CORRECTION TO THE TECHNICAL NOTE BY HOLBURY CONSULTANCY SERVICE ON BEHALF OF
TOURNERBURY ESTATE FOR APP/23/00076 [REDACTED]

‘Change of Use of land and woodland (retrospective) as a wedding and events venue...
Construction of vehicular track from the public highway to the proposed wedding and events
venue at Tournerbury Wood, Tournerbury Lane, Hayling Island’

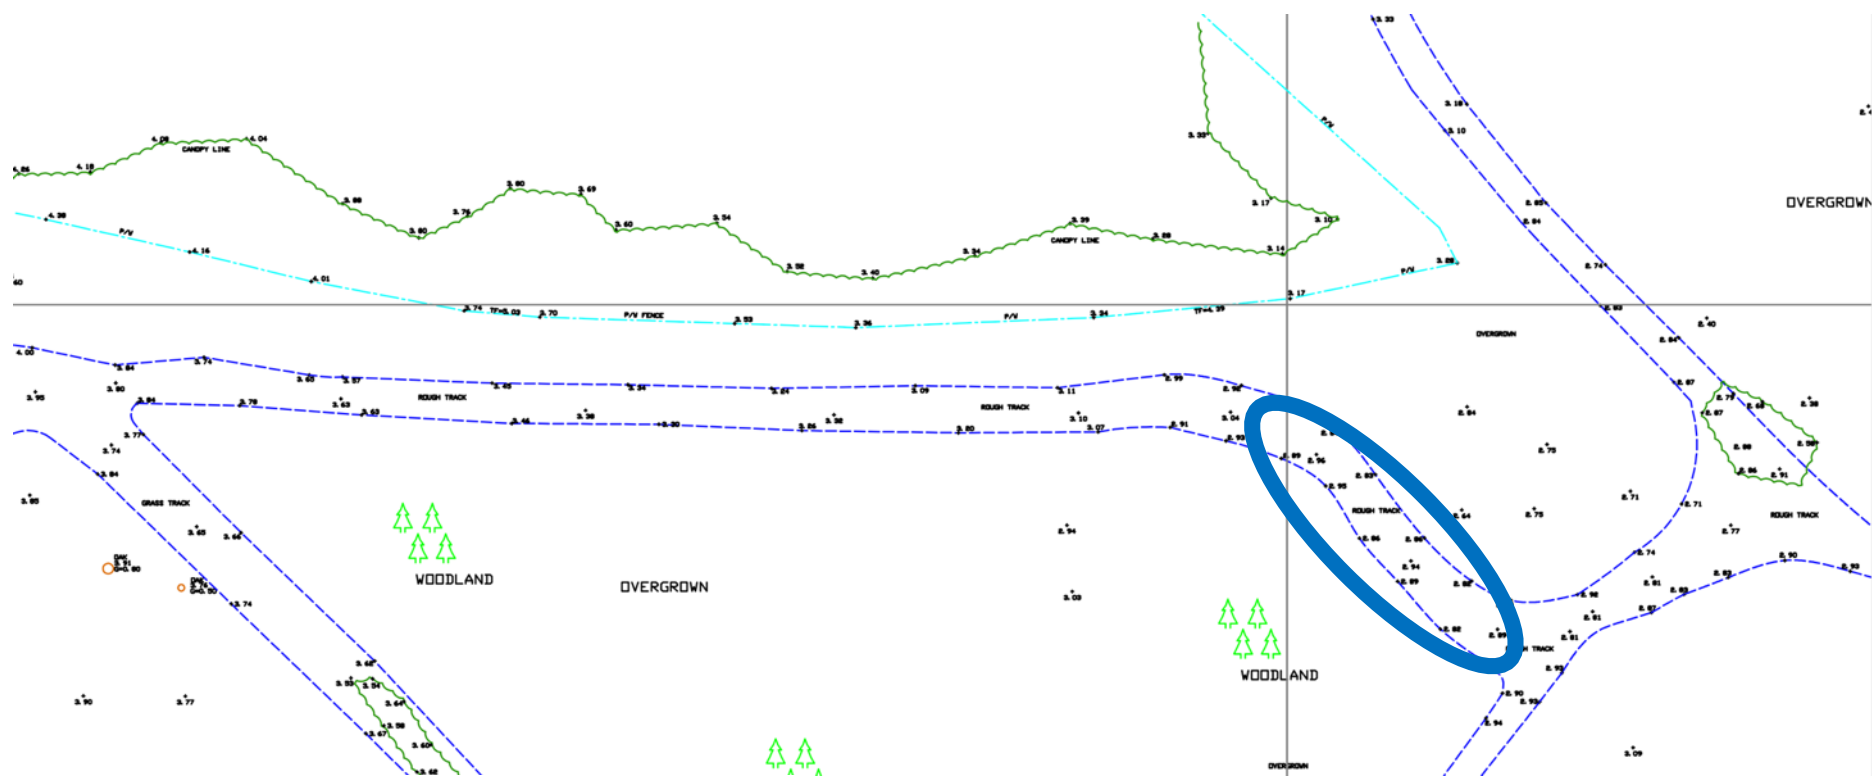
View of the first 200m of the track along the northern boundary of Tournurbury Wood showing current grass cover and insufficient width at point X for onward extension without tree cutting. This track is not in regular use by Tournurbury Estate and is fully grass covered.

Section of the track along the northern boundary of Tournerbury Wood showing rutting indicating no solid base and proximity to trees that would have to be felled to widen the track
